**Re: 5 Tamworth Place, Allambie Heights – BCA Report**

This statement provides a BCA Assessment Report, for the purposes of the Development Application being submitted to the Northern Beaches Council, for a proposed Secondary Dwelling within the existing dwelling.

The plans reviewed for the proposed secondary dwelling are as detailed in Drawing Nos 5A Sheets 1 to 4 prepared by Peter Formosa dated 27 March 2019. This includes;

**Figure 1 – Horizontal Projection (Spandrel)**

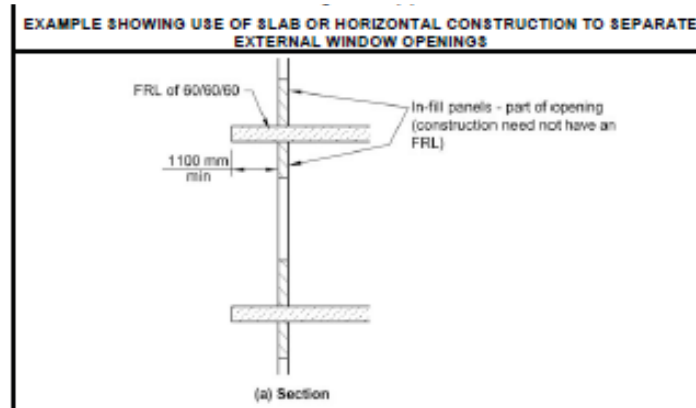
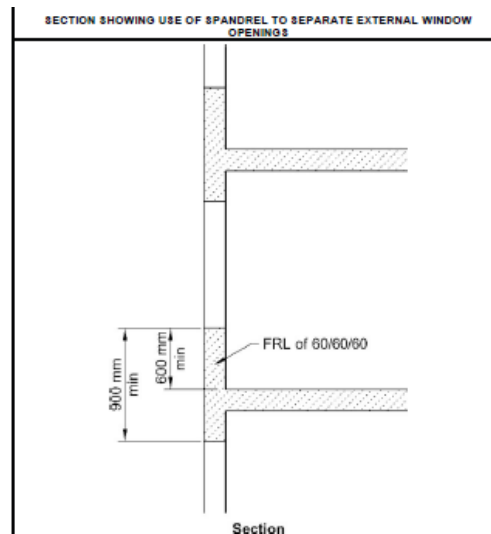
The openings in the external walls of the Main Dwelling that are above the window / doors in the Secondary Dwelling are separated by either masonry greater than 900mm high or the intervening floor of a balcony that is greater than 1100mm. This is therefore considered to satisfy the BCA or is addressed in Section B above.
